HOWARD COUNTY DEPARTMENT OF INSPECTIONS, LICENSES AND PERMITS
 7125 Riverwood Drive, Suite D2 ■ Columbia, Maryland 21046 ■ 410-313-1823

MEMORANDUM

SUBJECT: Sign Variance Petition: BA-26012S “Encore at Turf Valley”
 Variance Package Acceptance Date: May 13, 2026. Revision May 21, 2026.
 Sign Permit Application: S26000073
 Petitioner: Harmony Hall at Howard County Health Park, LLC
 1205 York Road – Penthouse, Lutherville, MD 21093
 Counsel for Petitioner: Samuel J. Mangione
 Sign Location: 6336 Cedar Lane, Columbia MD 21044

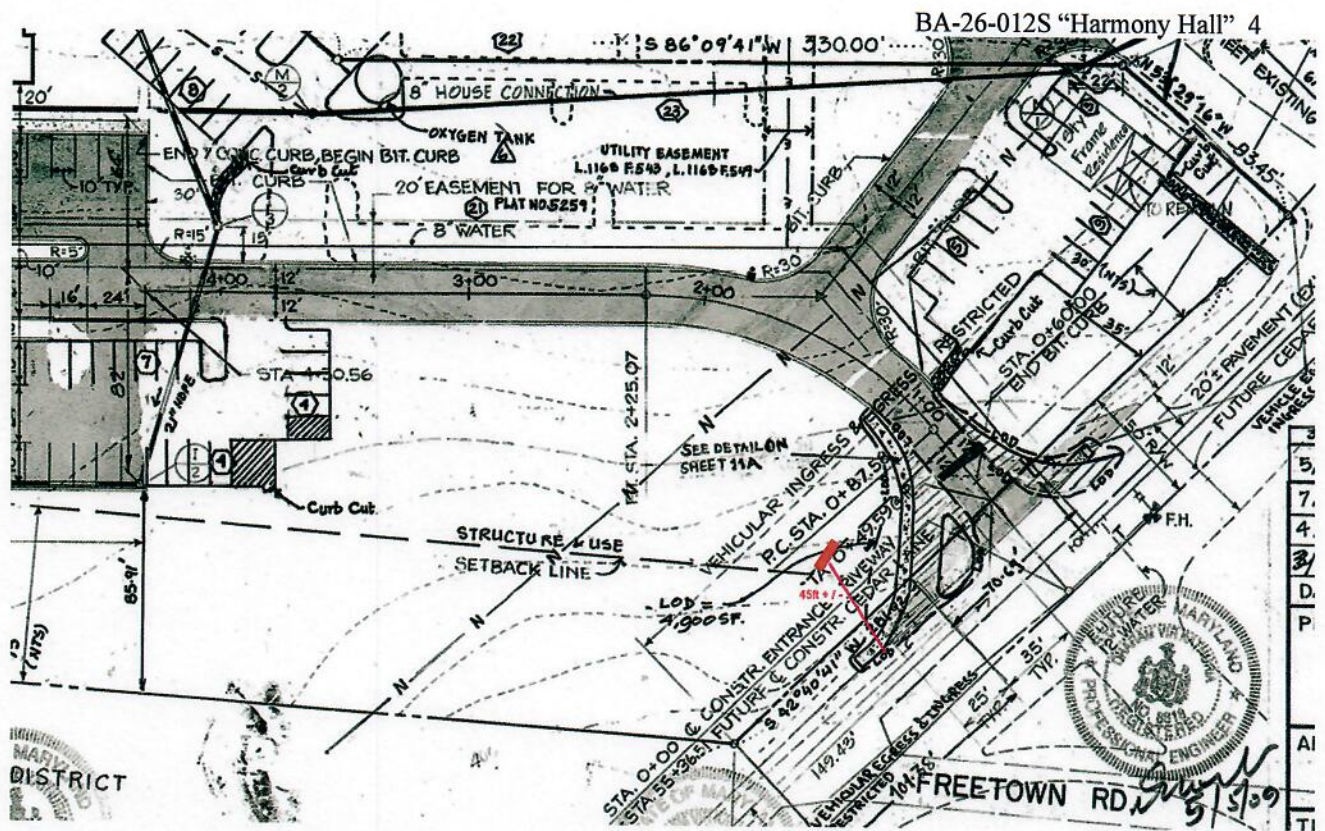
Figure (C): Per the submitted site development plan from the petitioner, the red mark above reflects the spot the sign will be installed. (~45 feet from the Cedar Lane right-of-way). Per code, the setback requirement for this size sign would be 169.5 feet from the right-of-way, putting it somewhere in the middle of the parking lot, out of any potential line of sight from the roadway.

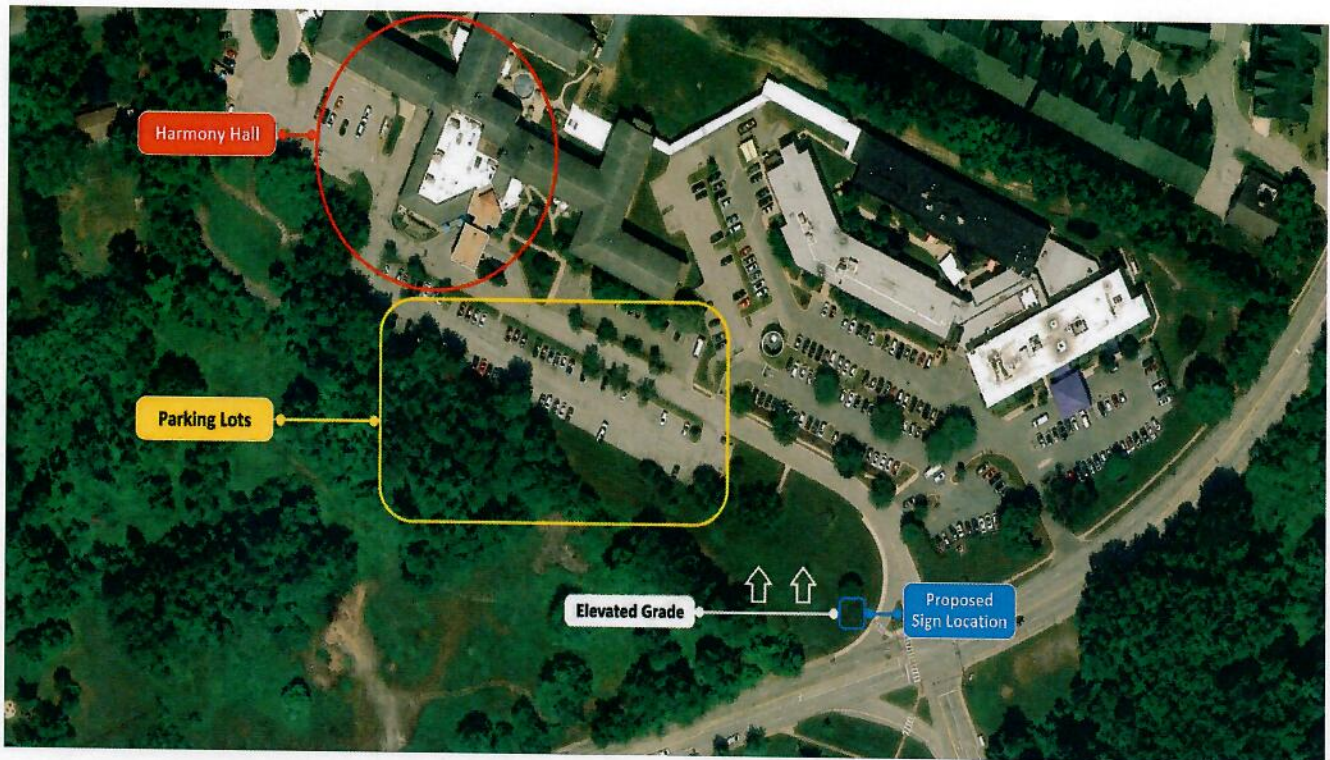
Figure (E): Google Maps view showing the Harmony Hall (red circle) building in relation to Cedar Lane. The yellow square represents parking lot area in front of the building. The blue square shows the approximate sign installation location (and where the existing sign is located, with white arrows representing the elevated grade from Cedar Lane.

Yes. In addition to the winding road noted previously, the facility is located at the top of an elevated grade (represented in the white arrows in Figure (E)) and fronted with parking lots, which mostly obscure visibility of the facility from Cedar Lane.
